HOLTEC INTERNATIONAL

**HI-STORM 100 SYSTEM
CERTIFICATE OF COMPLIANCE 72-1014**

LICENSE AMENDMENT REQUEST 1014-2

**Holtec Response to Request For Additional Information
Holtec International HI-STORM 100 Amendment Request, TAC L23564
License Amendment Request 1014-2, Revision 1, Docket 72-1014**

CoC Appendix B, Tables 2.4-1 through 2.4-3 provide limits for intact and damaged fuel assemblies. In light of the thermal evaluation addressing damaged fuel in FSAR Section

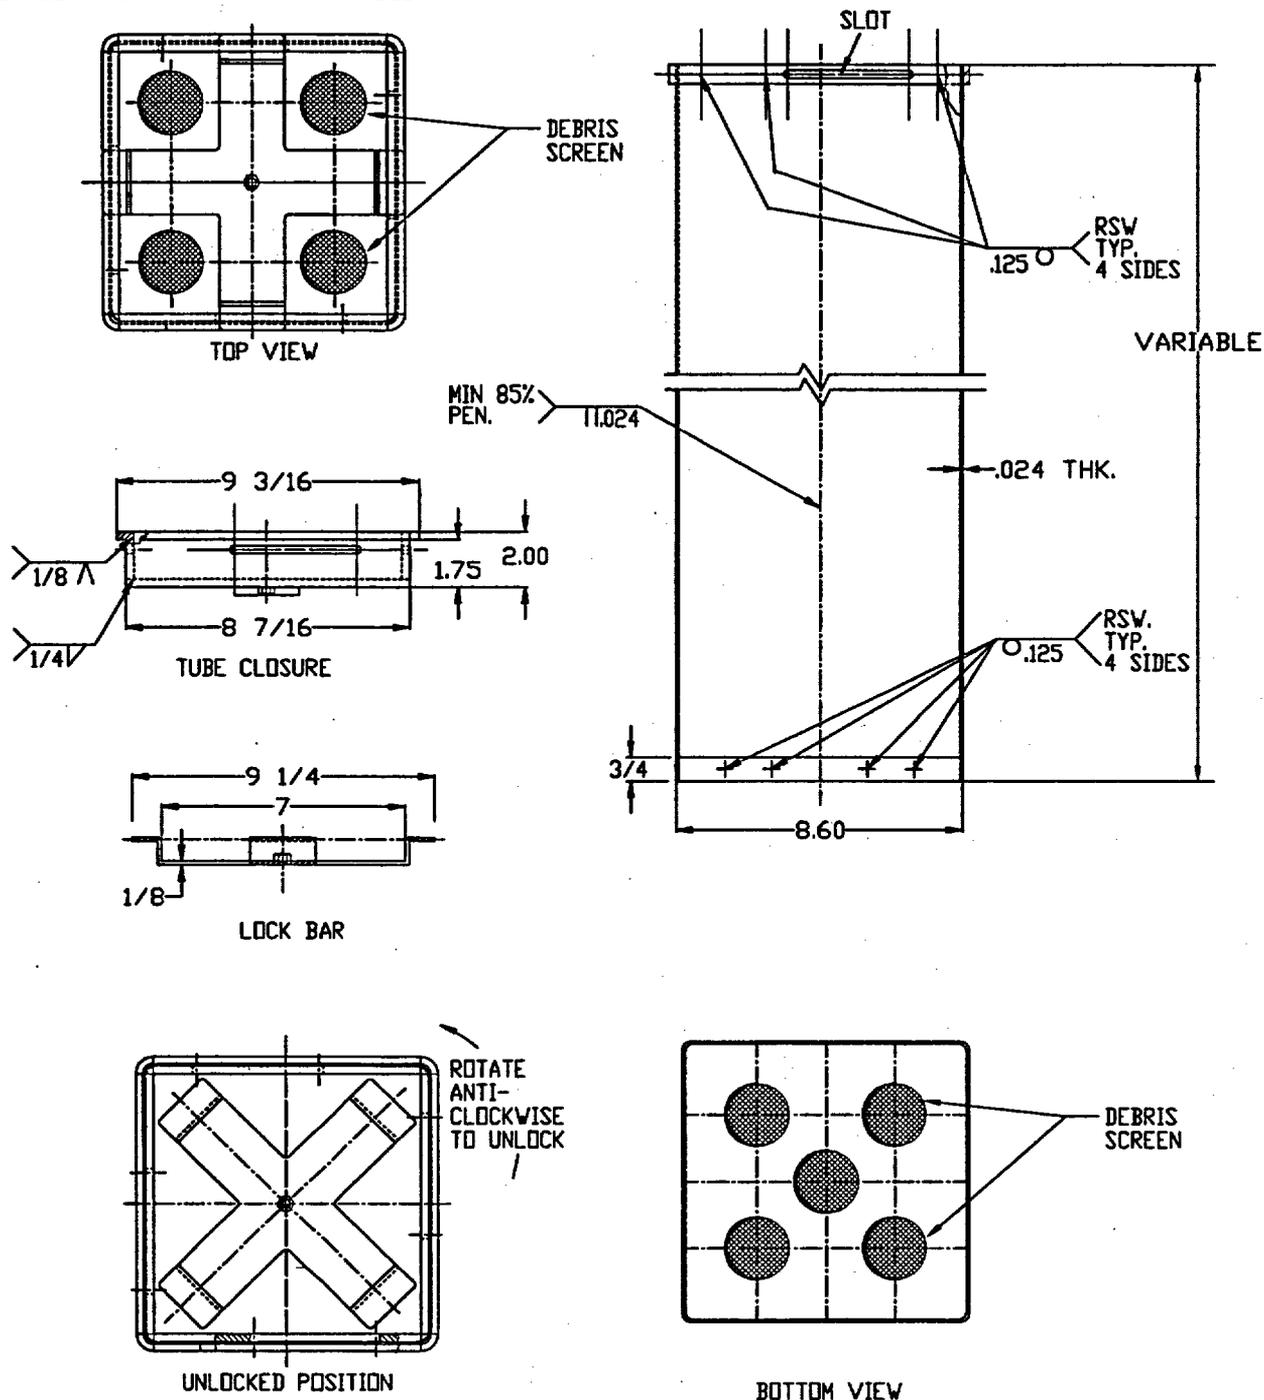
Section 2.1.3 notes that the DFCs for the Multi-Purpose Canister (MPC) 32F that is proposed in Amendment 2 are stainless steel and are provided with 250 x 250 fine mesh screens. Figure 2.1.2D provides some related information on the DFCs in terms of general dimensions and design concept, however Table 2.2.6 that lists the Materials and Components of the HI-STORM 100 System does not address the DFC, its components or its safety class. This relates to the HI-STAR 100 (Docket 71-9261) Amendment 1 Request, RAI 1-2, dated February 25, 2003.

In response to this question, we have re-reviewed all DFC figures in the FSAR to ensure they include key design information, such as dimensions, materials of construction, and design codes. Figures 2.1.1 and 2.1.2D were updated accordingly. Furthermore, we should note that the DFC's characteristics currently listed in Revision 1 of the HI-STORM FSAR, Table 2.2.6, include information such as the safety class, applicable design code, and materials. The codes applicable to the material, design, fabrication, and inspection of the DFCs are also listed in FSAR Table 2.2.7. For clarity, Table 2.2.6 has been enhanced to clarify the material specification and the applicability of ASME Section III, Subsection NG. We have also created new FSAR Section 3.4.4.3.1.9 to include a summary of the DFC structural analyses and results. [The details of these structural analyses can be found in Holtec Report HI-2012787, Revision 4, Supplements 24 and 25. Revision 3 of this report was previously submitted to the NRC on this docket on November 3, 2002. Revision 4 of this report was submitted to the NRC on Docket 71-9261 on May 29, 2003.]
